CITY OF ALBUQUERQUE

**RE: Volcano Cliffs Subdivision Lot 28 Block 1 Unit 22
8011 Canoncito Dr NW
Grading and Drainage Plan
Engineers Stamp Date 7/12/16 (D10D003N28)**

GRADING AND DRAINAGE PLAN
LOT 28, BLOCK 1, UNIT 22, VCS
ADDRESS: 8011 Canoncito Dr. NW

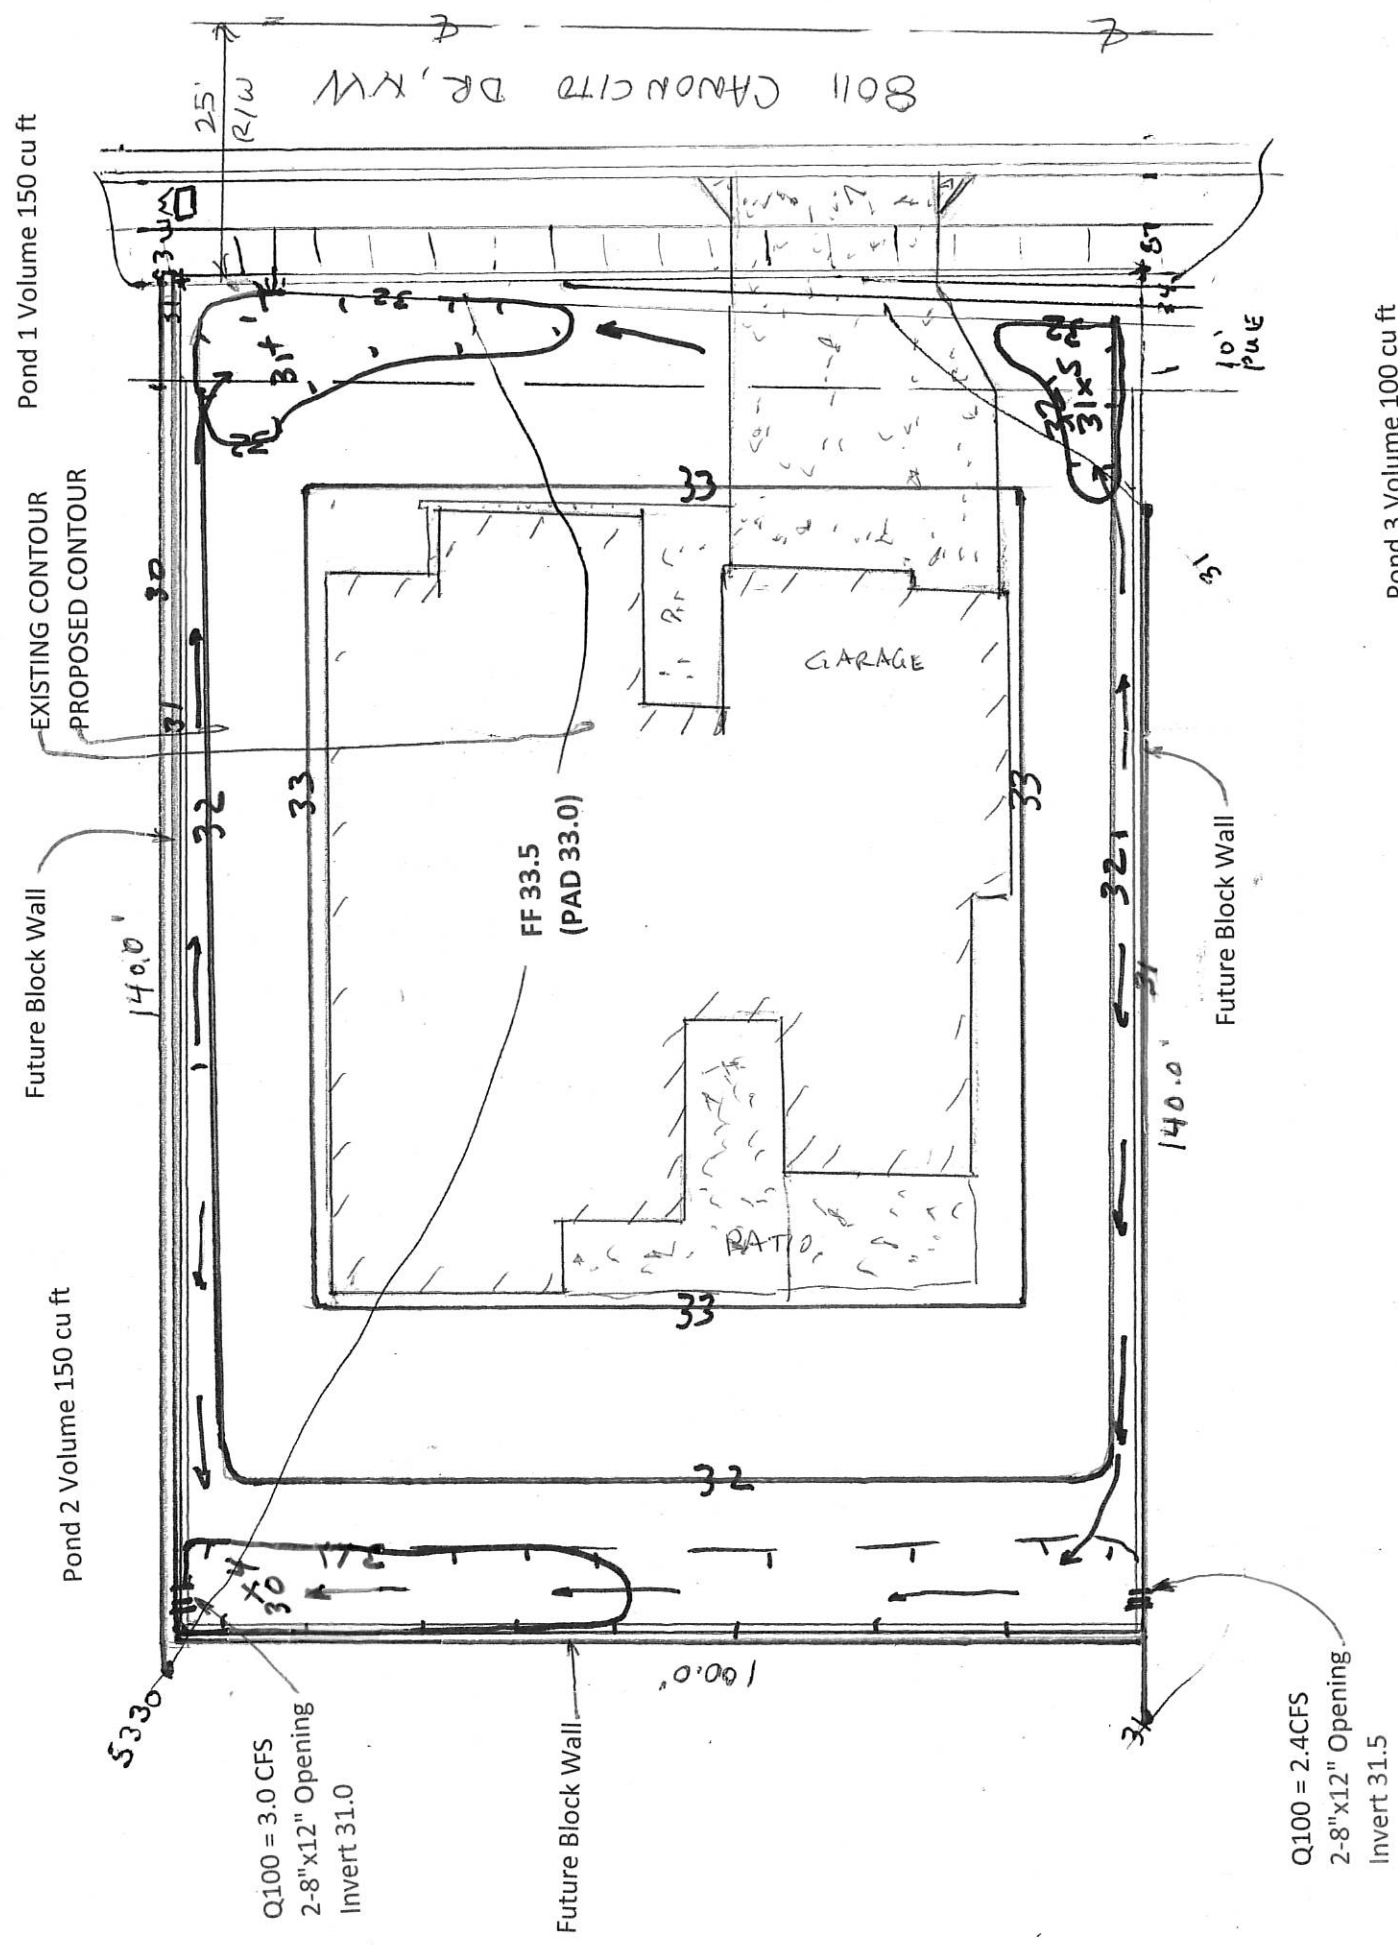
Based upon the information provided in your submittal received 7/12/16, this plan is approved for Grading Permit and Building Permit.

Please attach a copy of this approved plan to the construction sets in the permitting process prior to sign-off by Hydrology. Also, please advise the owner/contractor that a separate wall permit must be obtained and this approved grading plan dated 5/5/16 must be provided with the wall permit application. Also, please advise the contractor/owner that the ponds must stay in place or CO will not be granted.

Prior to Certificate of Occupancy release, Engineer Certification per the DPM checklist will be required.
